CONSTRUCTION DOCUMENTS GRADING & EROSION CONTROL PLAN

CBP, F2-LOT #21 - CRACKERJACK MUD JACKING, INC 7315 McCLAIN POINT, COLORADO SPRINGS, CO

PCD PROJECT NO. PPR-17-03

Markup Summary

GRADING COVER SHEET

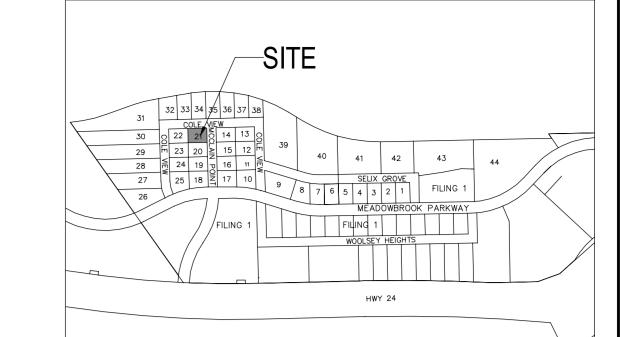
Unresolved: Provide the actual information.

GRADING PLAN

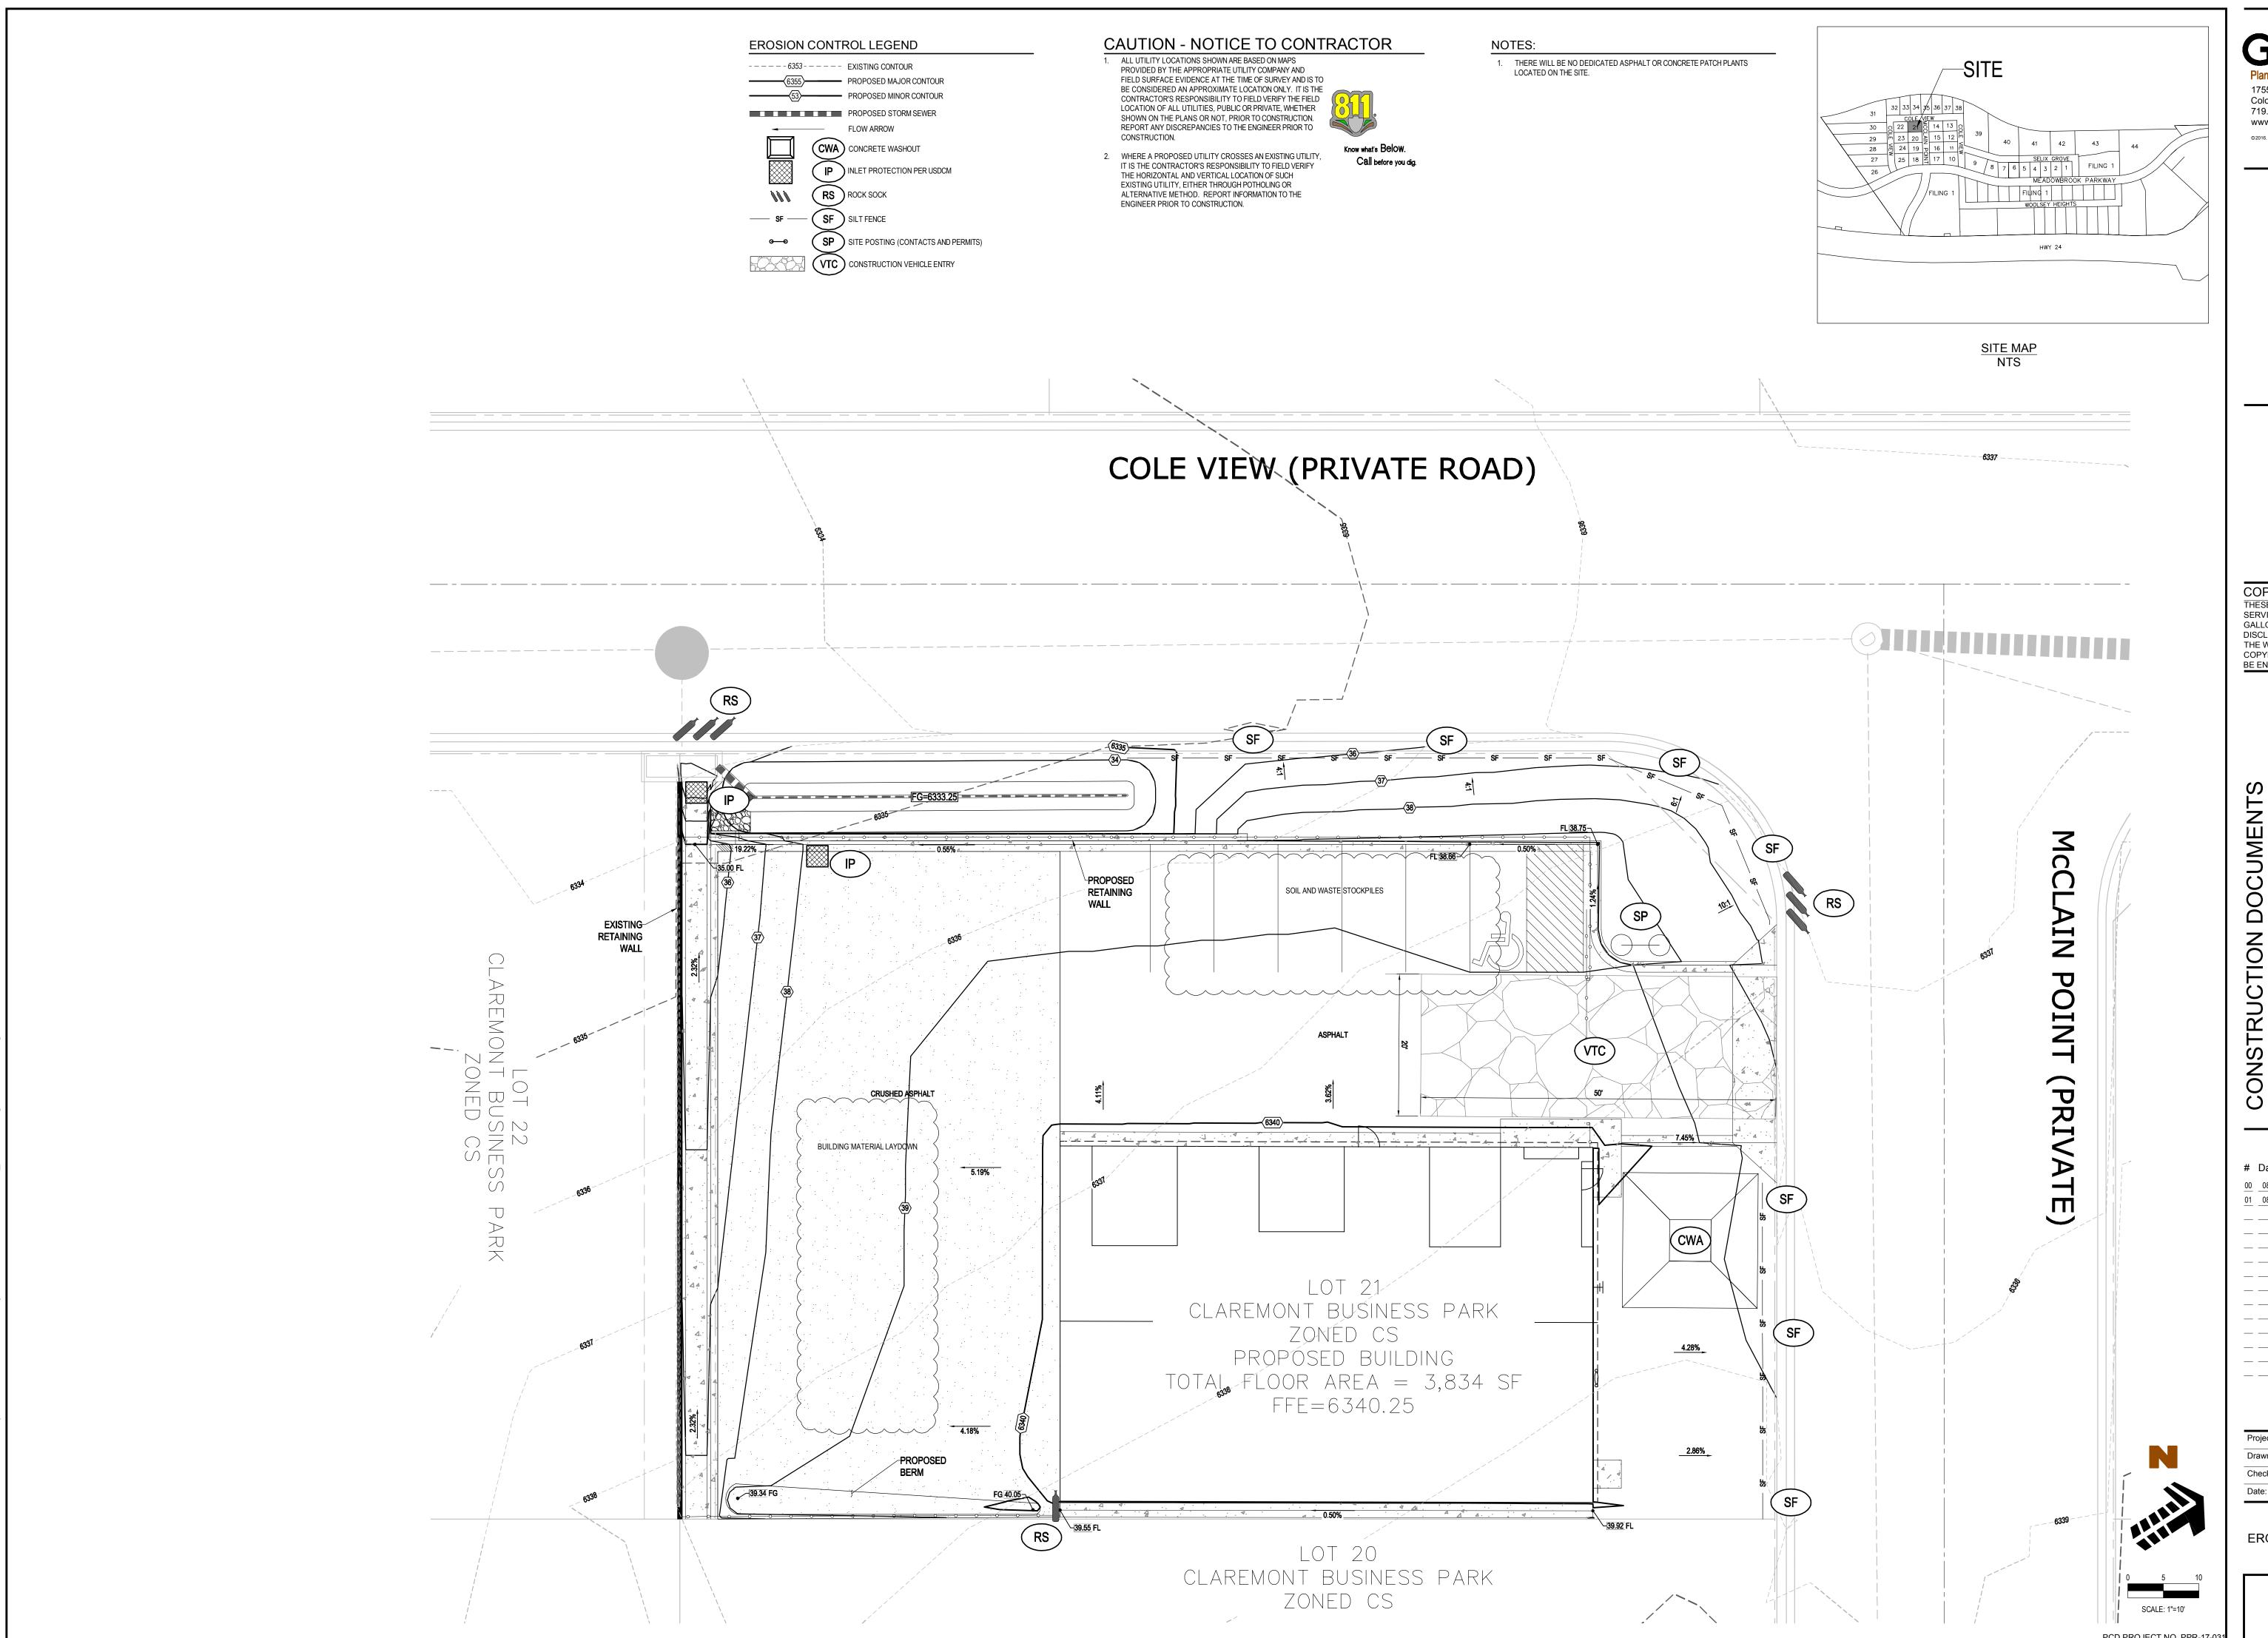
Remove the reference to the Site Plan. The resubmitted site plan does not include details for

the retaining wall.

Is the lower TW supposed to be top of curb (TC) or

BW?

RAIN GARDEN DETAIL

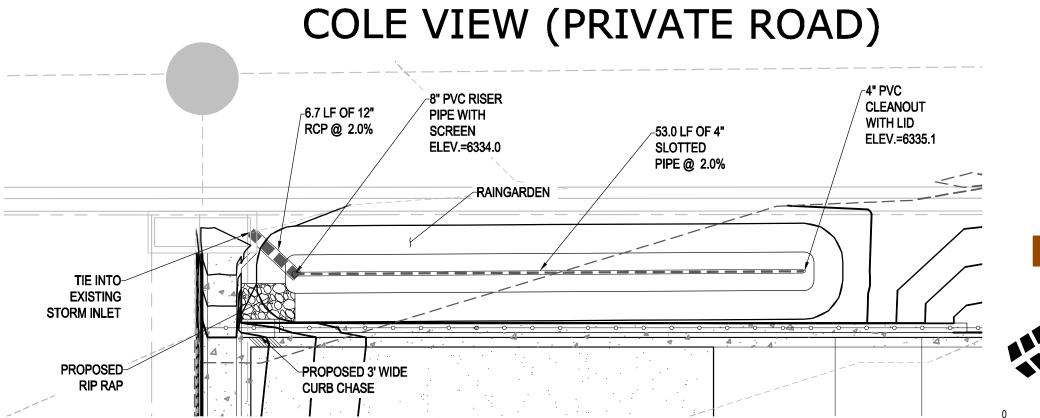
call out for water

tight cap. PROPOSED 4" PVG-SLEAN OUT SLOTTED PVC CONNECT 4" 90° PVC -TO CIP FITTING BEND PROPOSED PROPOSED 4" CIP BEND/TEE FITTING SLOTTED PVC PIPE RAIN GARDEN RISER PIPE Per the drainage letter provide a restrictor at the

end of the slotted PVC pipe with 1/2" diameter orifice for 12 hour drain time.

Riser screen and WQCV Elevation must me at the same elevation. As designed, the top 0.25' of the WQCV does not get treated through the filter.

Revise to note water tight lid.

Remove. WQCV shall drain through the filter then

into the slotted pipe.

Page Label: 3 call out for water tight cap.

Per the drainage letter provide a restrictor at the end of the slotted PVC pipe with 1/2" diameter

orifice for 12 hour drain time.
